SSD-10405 ATLASSIAN CENTRAL

Section 4.55 Modification - MOD 3

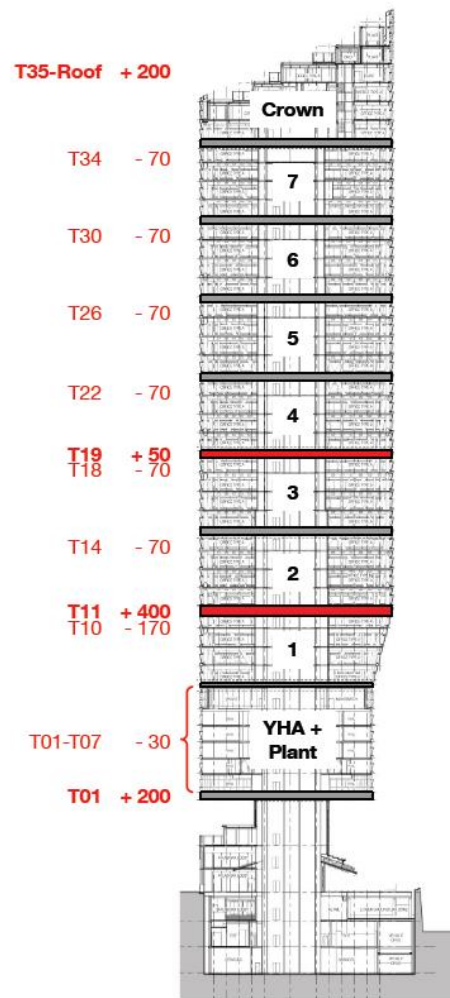
Level	Height difference
T01 – T06 (YHA and plant)	-30mm total
Typical habitats	-70mm each
Habitat 1	+400mm
Habitat 3	+50mm
T35 – Roof (Crown)	+200mm total
Plenum Heights	
Habitat Level 4s	-70mm each
T10	-170mm (100mm shallower beams, but typical penetration height maintained)
Transfer to Crown (T34)	No extra height (+170mm in comparison to 25% DD)
T35-T38 (offices)	+70mm each (-250mm on T35 in comparison to 25% DD)
T38-Roof (plant)	+10mm total.

These changes are wholly within the approved building envelope and will not have any perceivable changes to the building form.

Figure 3 Habitat Level 4 floor extension

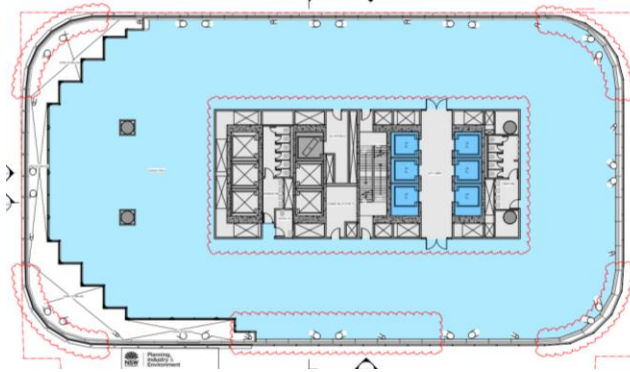
Design development of Level 4 in each Habitat is proposed to resolve maintenance, air flow and fire safety issues. The key aspects of this change are as follows:

- This floor will no longer have connectivity to the atrium.
- The extension of the floor is supported by the mega floor by steel hangers.
- This design change will result in the removal of the bulk head between Level 4 and the façade which impeded air flow and had limited accessibility for maintenance.

- Enables a fire safety design solution to be achieved for the atrium spaces.
- Timber structure: structural grid updated per core structural realignment. Timber staggered corners spacing is kept consistent to meet design intent.
- Steel structure: mega floor steel structure is fire protected and is to be exposed.

Figure 4 Atrium section showing proposed timber fire protection

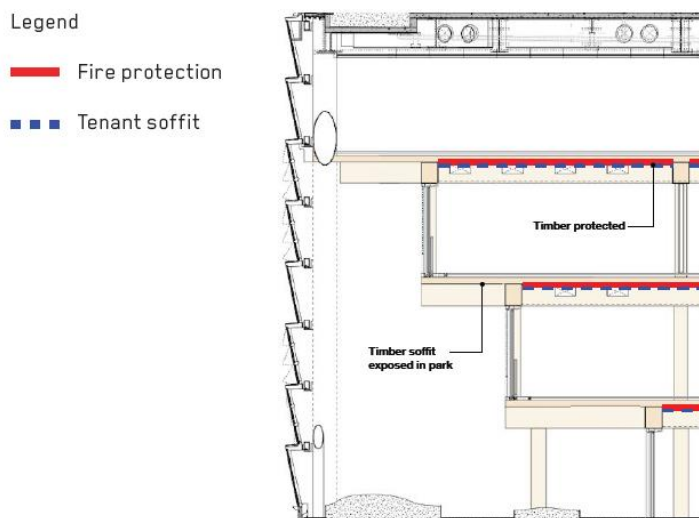
- All timber columns and beams will remain exposed and all slabs within these environments will be fire protected from underneath.
- The fire protection of the soffit is to be selected by the tenant and may vary across the building.

All timber structure remains exposed within the Type C Office Spaces.

Figure 6 Approved and proposed Crown façade

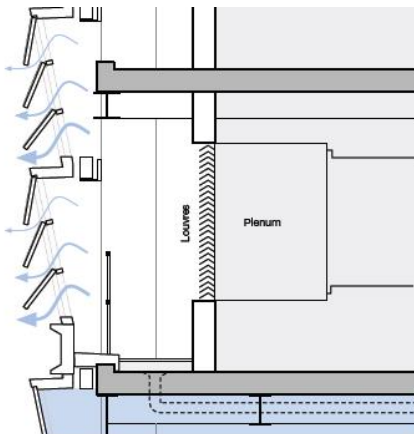
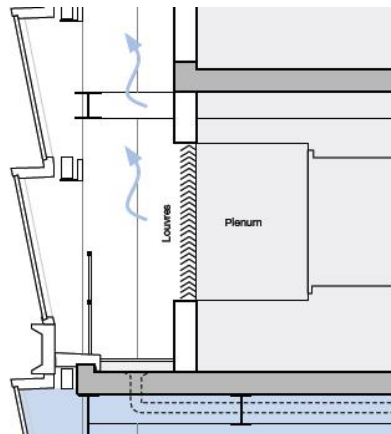
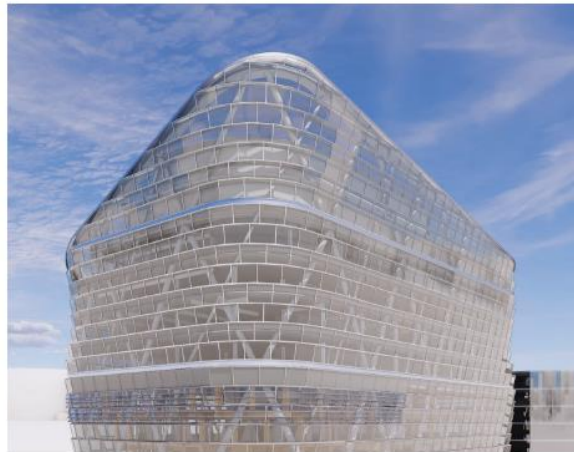
The Crown exterior facade in the north, west and south elevations is proposed to be modified from fixed glazed louvres to a fixed glazing panels to match the office levels.

To accommodate the change in airflow condition, a plenum is proposed between the double façade.

Figure 8 Western elevation showing proposed tower stack, structure and façade modifications

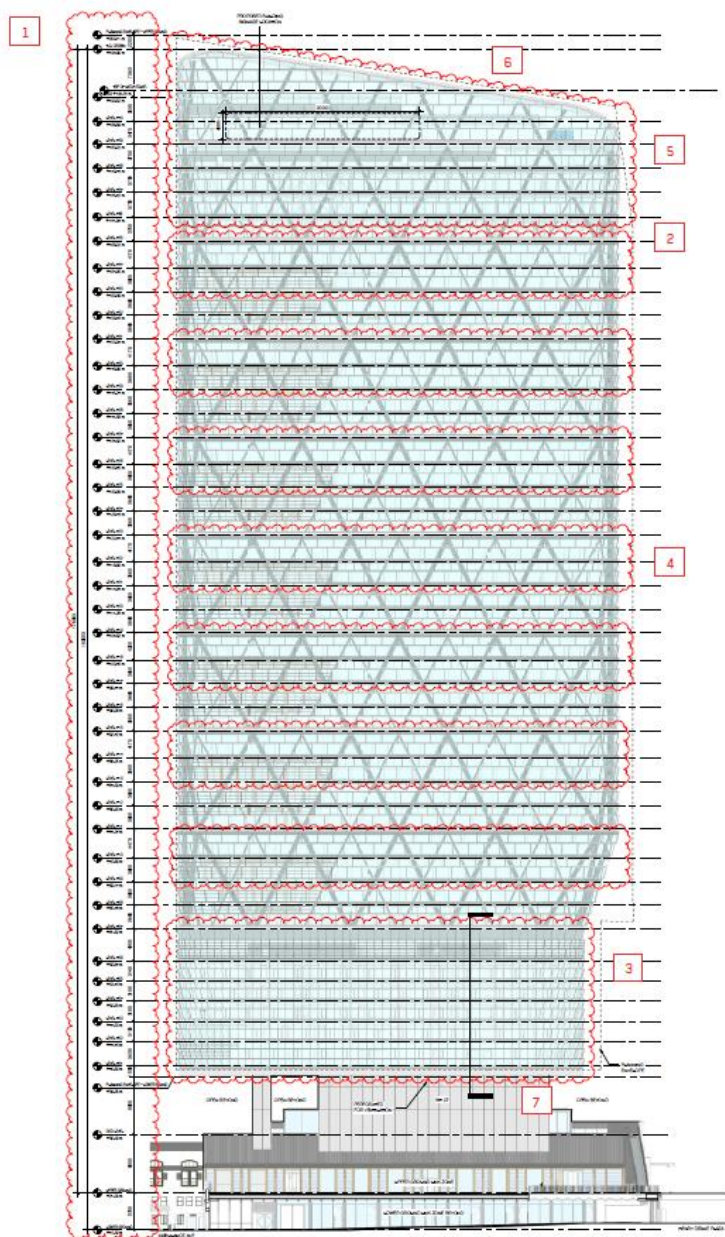
- Tower Stack: Floor to floor heights adjusted throughout tower (see **Section 3.2.1** above).

- Facade: Exterior finishes changed to powder coated aluminium.
- Facade: YHA Levels T01-T05: Updates to vertical modulation of units, operable louvers, awning windows, and safety screens.
- Facade: Office Levels T07-T34: Atrium space louvres reduced to 3 floor per habitat to achieve fire safety compliance and optimal airflow.
- Facade: Office and Crown Levels T07-T40: Extend use of fixed glazed panels to Crown, habitat Level 4, and Crown Plant.
- Crown Ring Beam: Changed from an architecturally exposed steel section to powder coated aluminium clad steel section.
- Tower Soffit: The tower soffit design has been further developed. The articulation of the panels intends to improve the legibility of this element of the building from several vantage points within the public realm.

Figure 9 Proposed modifications to low-rise, low-rise/high-rise transfer and high-rise habitat levels

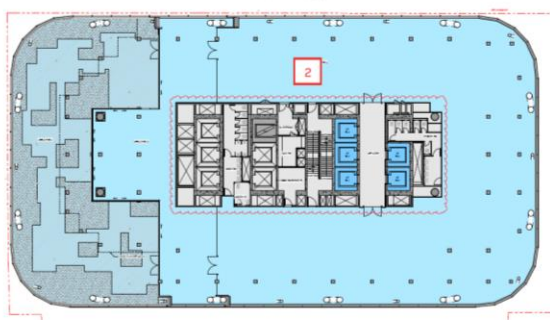
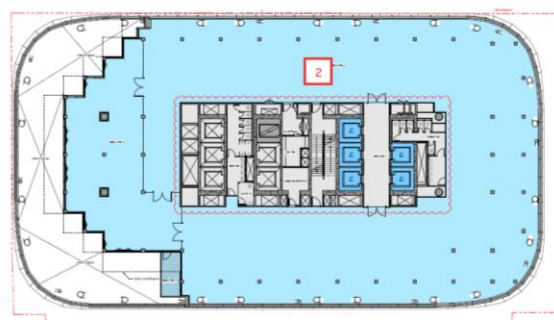
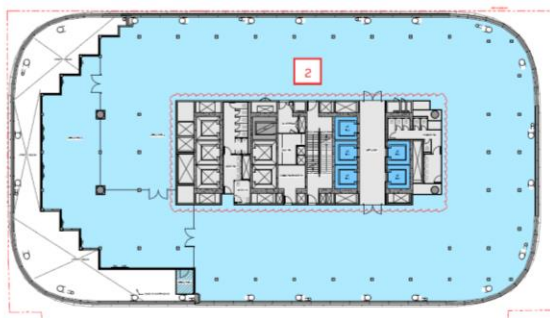
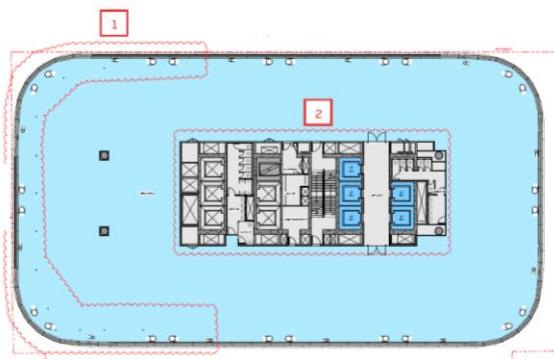
Core structural and spatial updates within these levels include:

- Reduction in sizing of structural core
- Adjustment of services risers and rooms
- Double deck lift system assumed as Basis of Design, rather than twin lift system
- Elimination of 1 low-rise, low-rise/high-rise transfer/high-rise lift
- Egress stair redesigned for use as intertenancy circulation, finishes and details updated accordingly
- Optimisation of amenities, including utilisation of former lift shaft area
- Lift lobby finishes revised.

Figure 10 Proposed modifications to high-rise-Crown transfer habitat levels

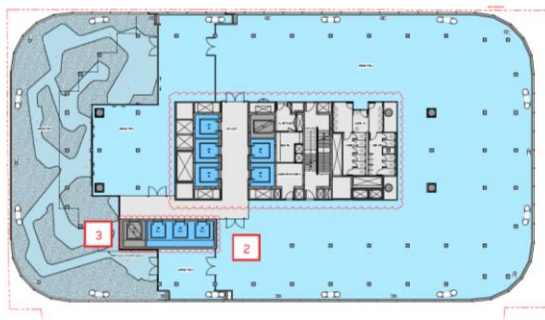
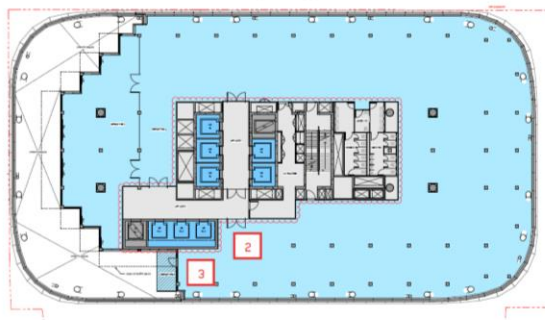
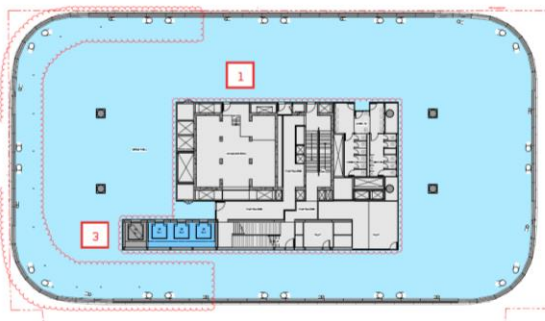
The same modifications identified in Section 3.2.7 above are proposed to this habitat.

In addition, the following modifications are proposed:

- High-rise core updates: Reduction in lift overrun height. This enables the high-rise core to terminate at the underside of T35 slab (one floor lower than previous), and Crown east core to begin at T35;
- Relocation of tower-to-Crown stair and services transfer from T35 to T34;
- Location of goods lift relocated to north position.

Figure 11 Proposed modifications to Crown levels

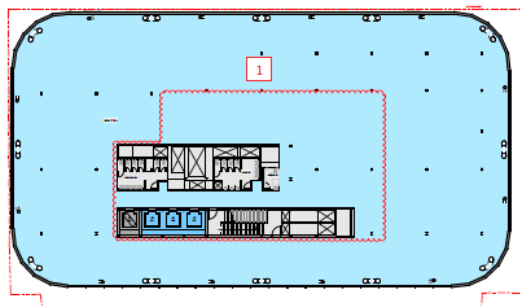
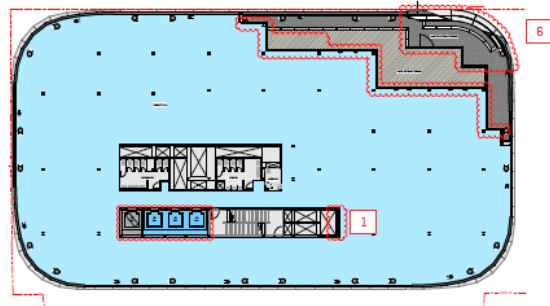
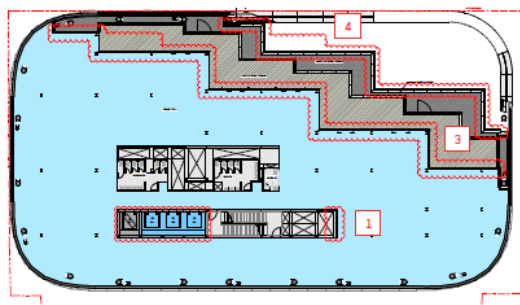
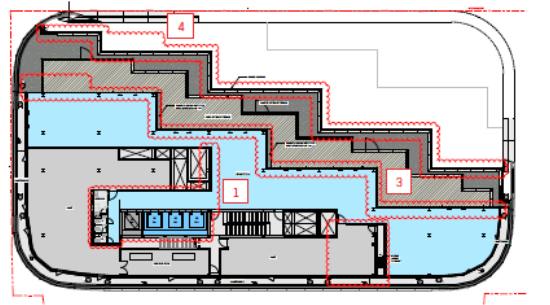
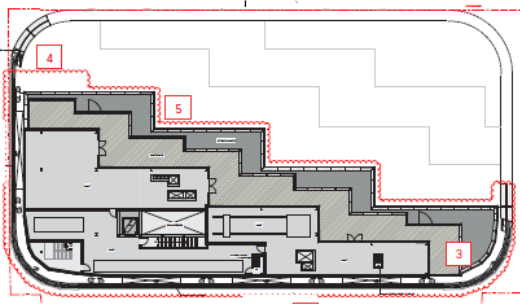
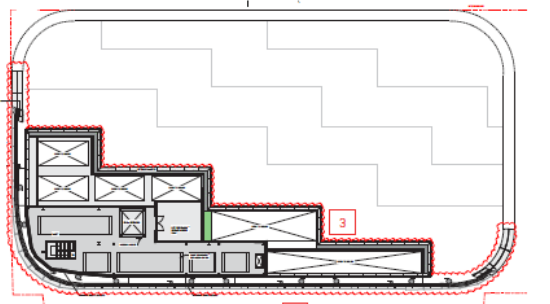
The following modifications are proposed to the Crown levels:

- Levels T35-T40: Adjustments to planning, including services risers, plant spaces, egress, and restrooms.
- Levels T39-T40: Elimination of slab and maintenance zone between the façade. Exterior facade on T39 and T40 in north, west and south elevations is changed to fixed glazed panels to match the office exterior.
- Levels T36-T39: Exterior facade facing terraces moved inward to comply with the sky plane.
- Removal of exterior stairs connecting terraces.
- Terrace space fronting plant area on T39 no longer accessible.
- Southwest corner on T36 is updated to resolve head height constraints on T35. This change has no impact on facades or terrace areas.

Figure 12 YHA Typical Section Modifications

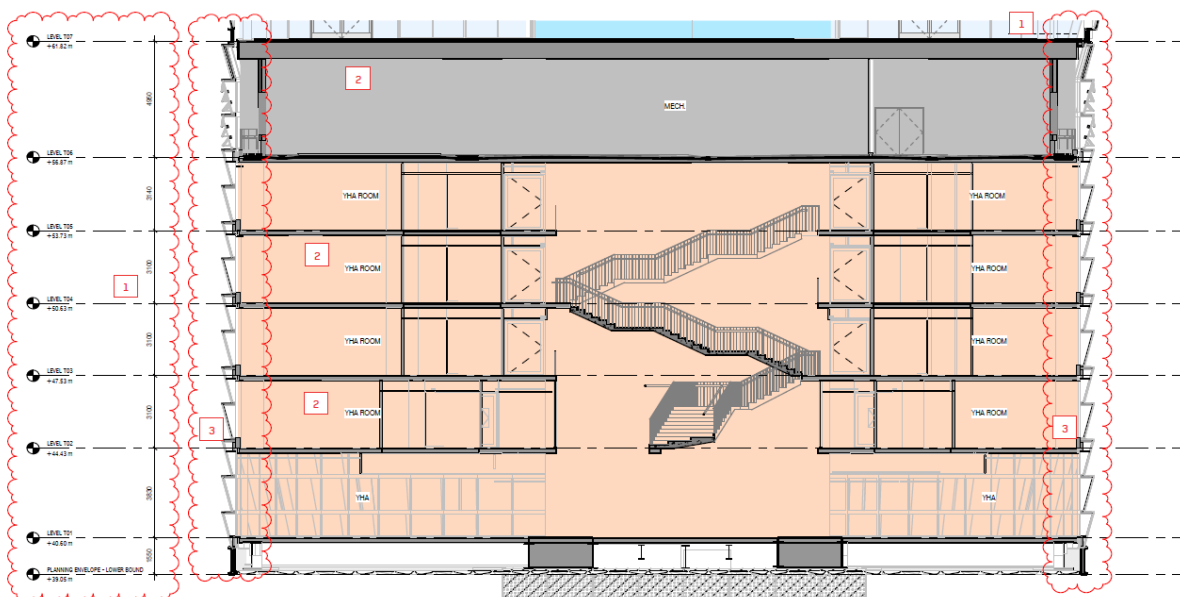
YHA Typical Section

- Relative Levels (RL) for levels 1-5 adjusted.
- Revised structural slabs thickness.
- Zig Zag facade adjusted to reflect adjusted floor levels.

Figure 15 Render comparisons of approved and proposed Crown facade

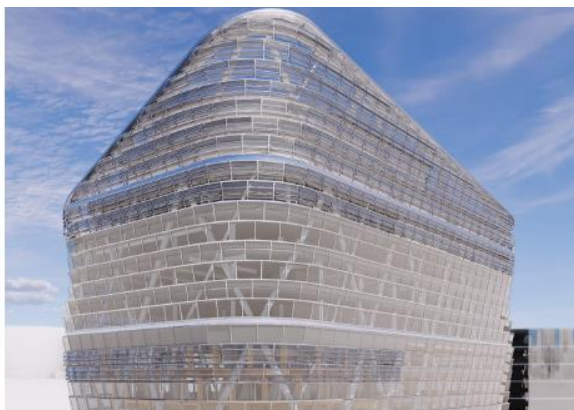
Proposed modifications include changing the fixed glazed louvres on the north, south and west elevation to fixed glazed panels. A vertical plenum is provided through the approved mechanical louvres on the interior façade into the vertical space between facades only. The Crown ring beam is proposed to be changed from an architecturally exposed steel section to a powder coated aluminium clad steel section, which will enhance the legibility of these elements of the building from the public realm.

The proposed modifications will have a limited discernability from the public realm, and where perceivable will positively contribute to the building design as demonstrated in the render comparisons below.
